ACCELERATED DISTRIBUTION DEMONSTRATION SYSTEM

SUBJECT: Forwards response to action items from 890616-17 long term seismic program fragility meeting.

Re: Docket No. 50-275, OL-DPR-80
Docket No. 50-323, OL-DPR-82
Diablo Canyon Units 1 and 2
Response to Action Items from the Long Term Seismic Program
Fragility Meeting, June 16-17, 1989

RESPONSE TO ACTION ITEMS FROM THE
LONG TERM SEISMIC PROGRAM
FRAGILITY MEETING, JUNE 16-17, 1989

Figure 1. Peak-Valley Variability when anchored to \bar{S}_a 4.8 Hz to 14.7 Hz

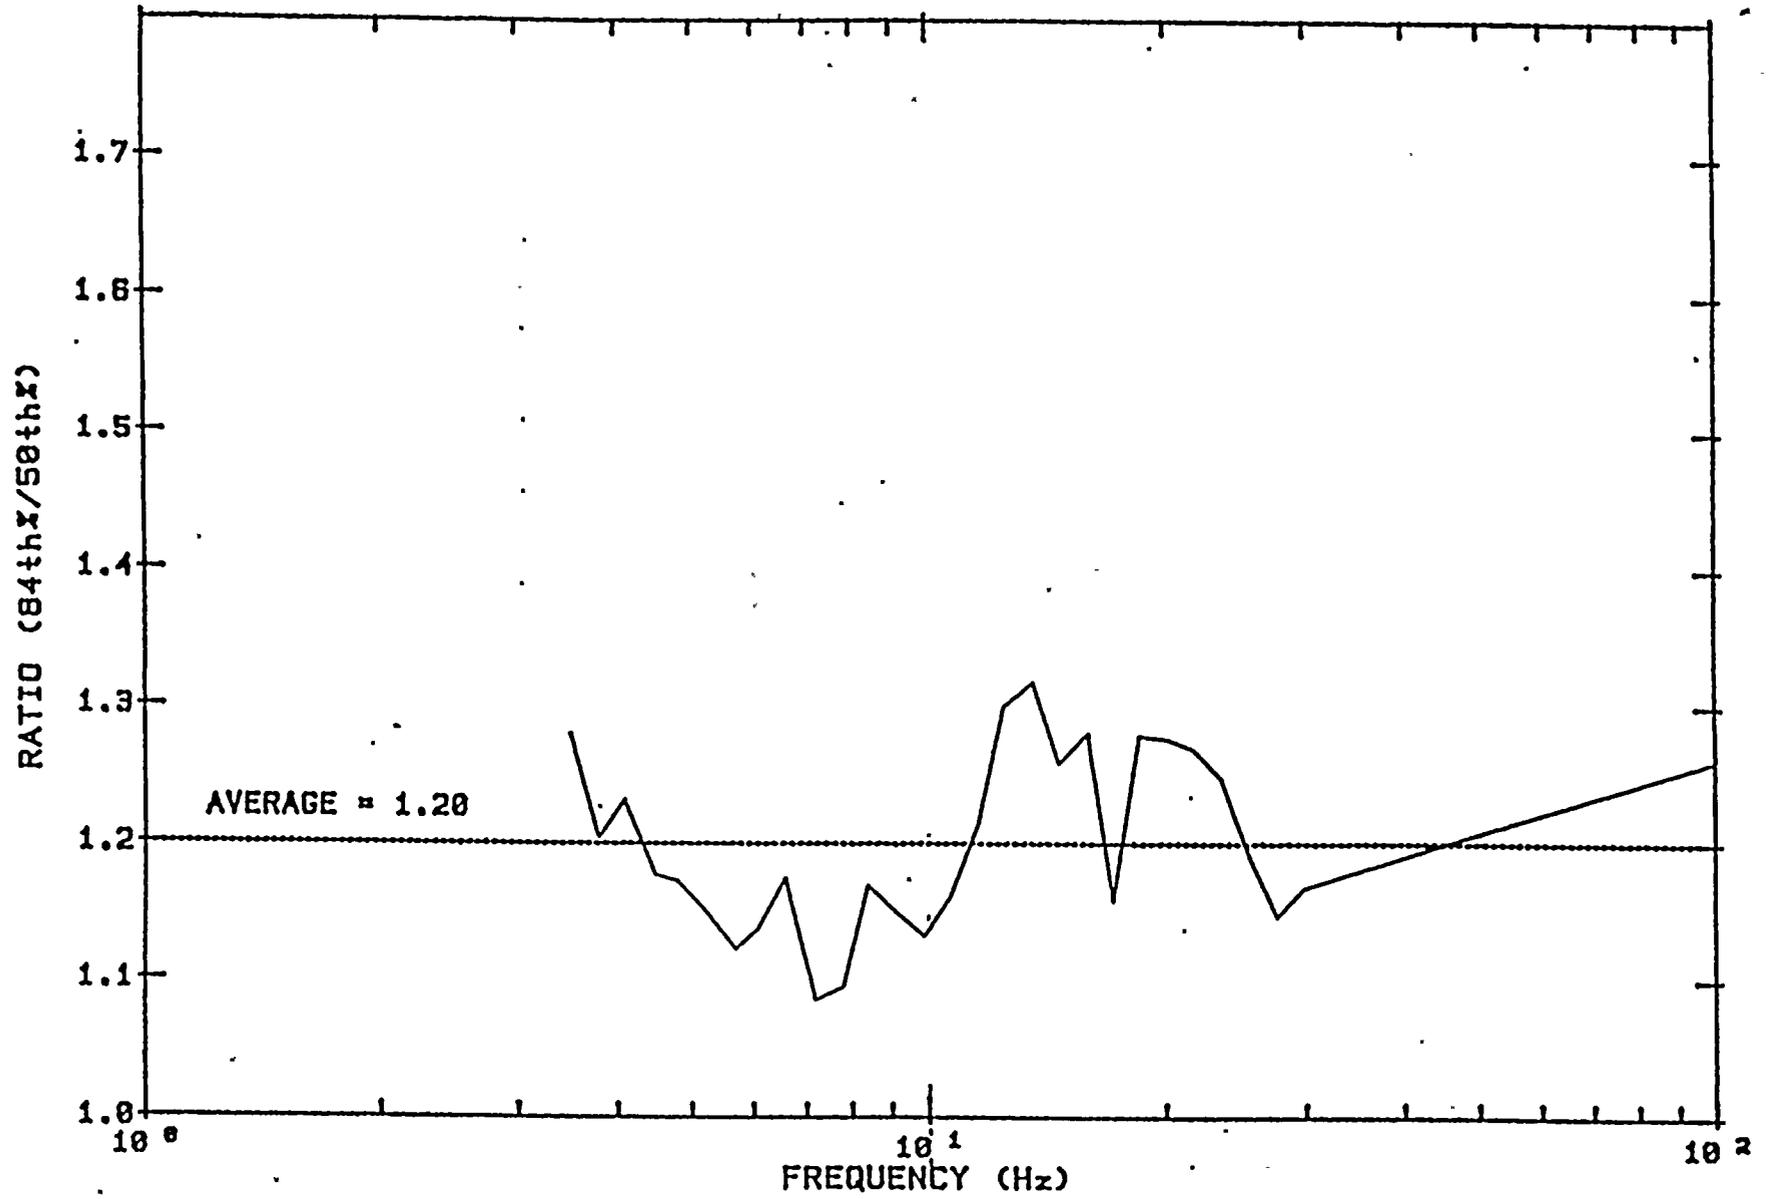
Provide a written summary of the presentation made at the meeting in response to the hazard/fragility interface question listed in Enclosure 3 to this meeting summary.

horizontal response components. Figures 1 and 2 present the ratio of 84%/50% AF when \bar{S}_A and PGA are used, respectively, as the ground motion interface parameter SAR. As can be seen in Figure 1, when \bar{S}_A is used, the ratio of 84%/50% AF can be taken to be 1.20 for all frequencies greater than 3.3 Hz, including the zero period acceleration (ZPA) which is plotted at 100 Hz. However, Figure 2 shows that when PGA is used, no reasonable constant value for the ratio of 84%/50% AF can be chosen for the entire frequency range from 3 to 30 Hz. One might choose a varying ratio ranging from about 1.4 at 3.5 Hz to 1.15 at 30 Hz. Alternatively, one might choose an average ratio of 1.33 from 3.3 to 15 Hz, but this ratio would be excessively conservative above 15 Hz. In the following discussions, we will make the former choice.
